Stationary Mounting Bracket Change

Mounting brackets changing from fabricated style to cast style

7 March 2011, from Chris Scahill, Product Manager – Transport Equipment

Figure 1

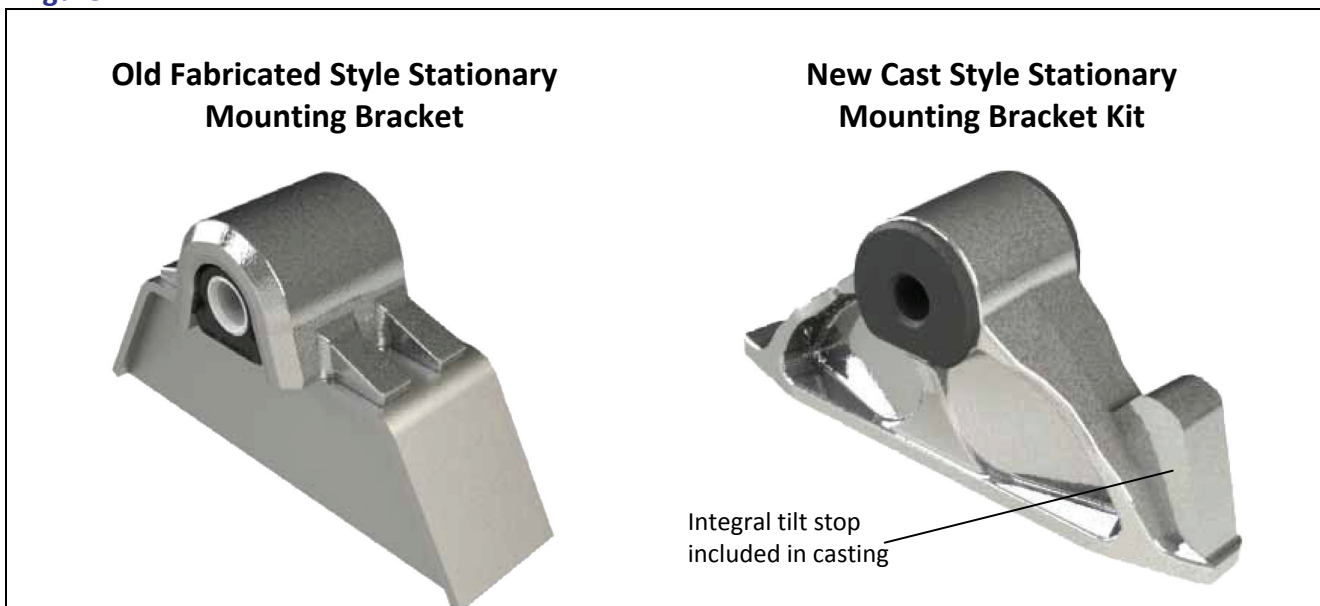
From March 2011, all Holland Fifth Wheel Stationary Mounting Brackets, except for the heavy duty and plate mount “dog bone” style, were changed from fabricated to a cast style (see Fig 1).

Stationary mounting brackets must be replaced in pairs. Never mix a new cast style bracket with an older fabricated style bracket. Combining a cast style bracket with an older fabricated style bracket may cause damage to the fifth wheel top plate and/or mounting system.

IMPORTANT: Stationary brackets must be replaced in pairs. Replacement Kits have been created to include both LH & RH new cast style brackets.

XA-7821

REPLACE WITH →

RK-X900
RH & LH Brackets

XA-7822

REPLACE WITH →

RK-X800
RH & LH Brackets

XA-7824

REPLACE WITH →

RK-X600
RH & LH Brackets

New Replacement Rubber Up Shock Bush = XB-10605
